HUME COAL PROJECT

Report No. 1716-12/2b

October 2018

Title: Supplementary Report
Independent Assessment: Hume Coal Project

Figure 1: Illustration of the extreme nature of the numerical model calibration point by reference to international subsidence behaviour (adapted from Galvin, 2016)

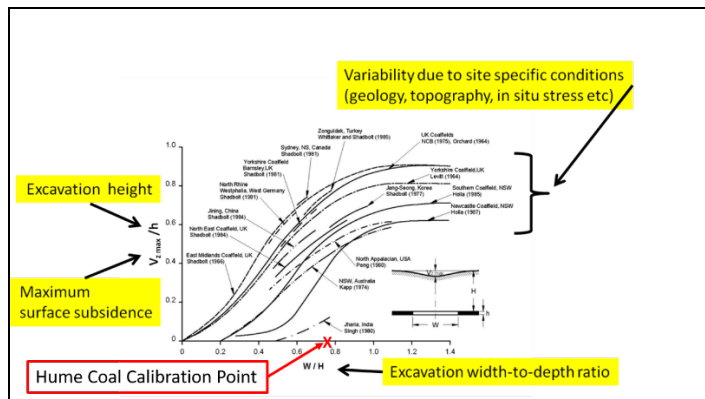
Caution is advised. Geology has a major influence on the stiffness of the overburden and, therefore, on confidence levels in the mine design since it determines the thickness of strata units, t' , (laminations) and their mechanical properties such as modulus, E , and Poisson’s Ratio, ν . This is reflected in t' , E and ν being the critical input parameters to LaModel. On the other hand, the same geometry (excavation width, W , and mining depth, H) can be associated with a wide range of overburden stiffnesses, depending on geology. These principles are reflected in Figure 1 and Figure 2 by the wide range in vertical surface displacement that can be associated with a given W/H value and by the subsidence behaviour reported for Berrima Colliery.

The extreme nature of the negligible subsidence is illustrated by reference to Figure 1 and Figure 2 (Figure 2 is incorrectly attributed to Galvin). As another point of reference, GAPL calculated predicted surface subsidence using the methodology and material values presented in the Hume Coal EIS. This approach predicts a surface subsidence of about 130 mm for the given dimensions.
